Docket Item # 16
BAR CASE # 2006-0283

BAR Meeting
December 20, 2006

ISSUE: Approval of four condominium buildings

LOCATION: 900 North Washington Street

Figure 1 - Site plan

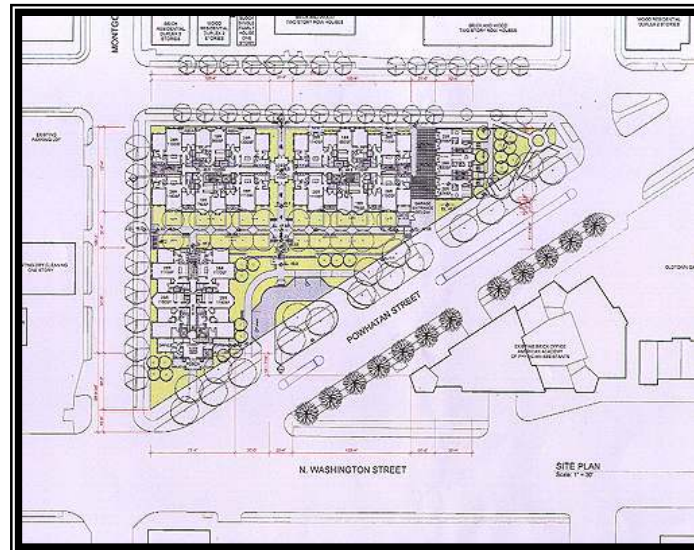
The proposed site plan includes a primary building fronting North Washington Street, two secondary buildings with a one-story connector, fronting North Columbus Street, and three attached, two-story townhouses fronting Powhatan Street. Open space within the project take the form of courtyard areas between the four buildings. Parking for the project is located underground, with access to the parking garage from Powhatan Street. An angled drive allows for passenger drop-off from Powhatan Street.

Figure 5 - Proposed North Columbus Street elevation for Certificate of Appropriateness Review

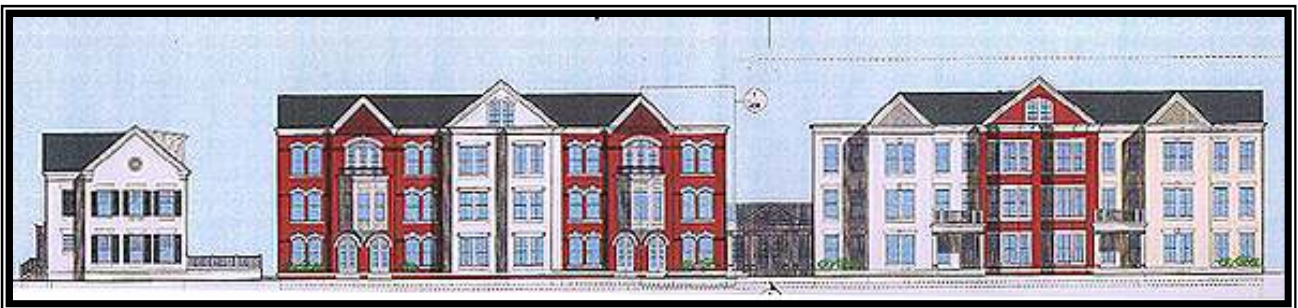
As discussed during the concept review, Columbus Street is characterized by smaller scale, generally two- to three-story townhouses. The two buildings fronting North Columbus Street have been revised considerably to respond to the concerns of staff and the community and the conditions of the Board. The height of the buildings has been reduced to the appearance of three-stories, while a fourth-floor-access to a rooftop terrace is provided by French doors set in a gable form, that is recessed approximately 30’ from the face of the building. At the street level,

the applicant has incorporated functional entrances, composed of rounded paired French-style doors. On the second floor of one of the buildings, a projecting oriel/bay window with a roof top porch provides architectural distinction and assists in breaking-up the long façade. A similar approach occurs on the second building in the form of a central bay with paired, three-story bay windows.

The one-story connector element between the two buildings serves as a functional entrance to the buildings. It is mostly glass with wood trim and mimics a conservatory.

The two buildings relate to one another but have different bay and window rhythms, porch expressions, and color. In respect to materials, the building share painted and natural brick as the primary exterior material, wood trim, precast stone lintels, wood and iron railings, and slate roofs.

1. Restudy approach to the height of the buildings fronting North Columbus Street, exploring options for mitigating appearance of 4th floor, or explore deleting the 4th floor.

1. Restudy approach to window shapes and lintel forms on North Columbus Street buildings, to avoid appearance of fragmented buildings.

2. Restudy the 4 story bay windows, change to 3 story bay windows on North Columbus Street buildings.

The applicant has responded to this condition by eliminating the residential units from the fourth floors of both Columbus Street buildings, changing the roof form of the building fronting North Columbus Street to a series of intersecting gables, so that most of the fourth floor is terrace area, removed from the face of the building. The greatly reduced fourth floor space that remains is used for mechanical and building commons areas. The total height of the buildings to the ridge is 45' 7 1/2".

The applicant has revised the buildings so that the building to the north end has primarily paired, arched windows on the outer bays and flat lintel paired windows on the center bay; while the building to the south end has flat lintels over paired and single windows. Staff believes that this approach is a sound design scheme, providing some elements that link the two buildings, yet providing some that distinguish them from each other.

The applicant has revised this element so that the bay windows have been changed from 4 stories to three stories or less.

Figure 6 – Approved Concept for Powhatan Street elevation

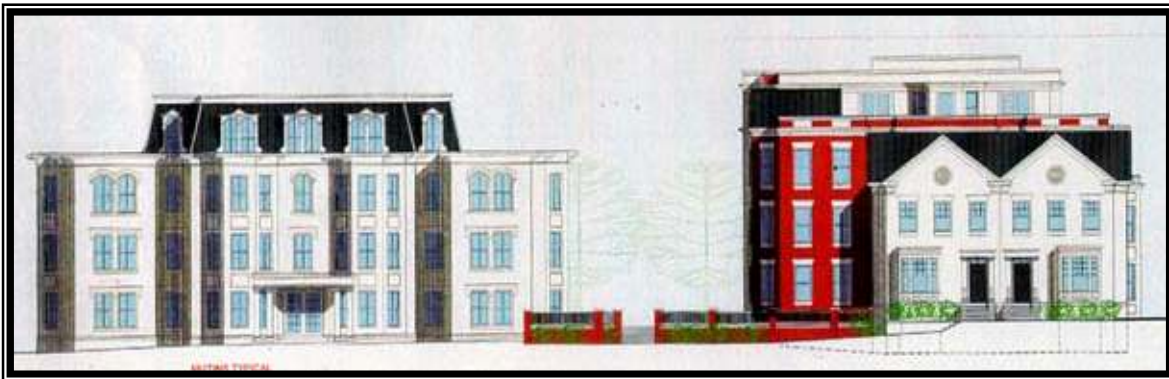
This is an element which has been positive and has continued to improve with the revisions to the plan. Three connected townhouses are now shown, each with two bays. The height of the stoops have been lowered and side gabled roofs have been added, with slate roofing. All of these elements combine to create a very successful form, mass and scale for these buildings. The units have also been refined to include window and bay elements compatible with the adjoining townhomes, (the Old Town Gateway project.) Windows have been incorporated below the water

table and on the sides of the projecting pavilion elements. Wood operable shutters, sized to fit the window openings have also been added.
